ADA Curb Ramp New Construction Inspection Form (Parallel)

311th

24952.54

Claxter

PARALLEL RAMP (PL)

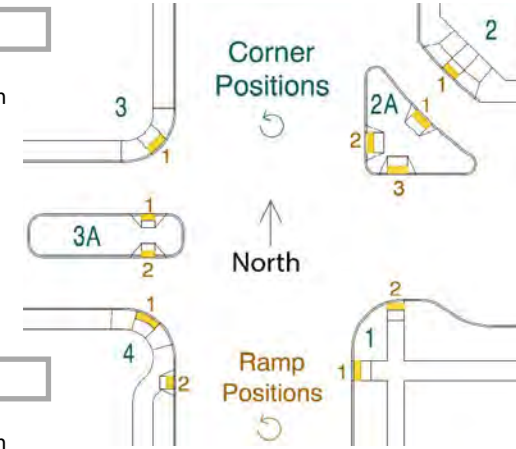
2.5 $\leq *$ ☐ $> *$ ☒

3.6 $\leq 2.0\%$ ☐ $> 2.0\%$ ☒

3.3 $\leq 2.0\%$ ☐ $> 2.0\%$ ☒

4.85 $\geq 4.0'$ ☐ $< 4.0'$ ☒

IITD, gt2. BOR drop off.
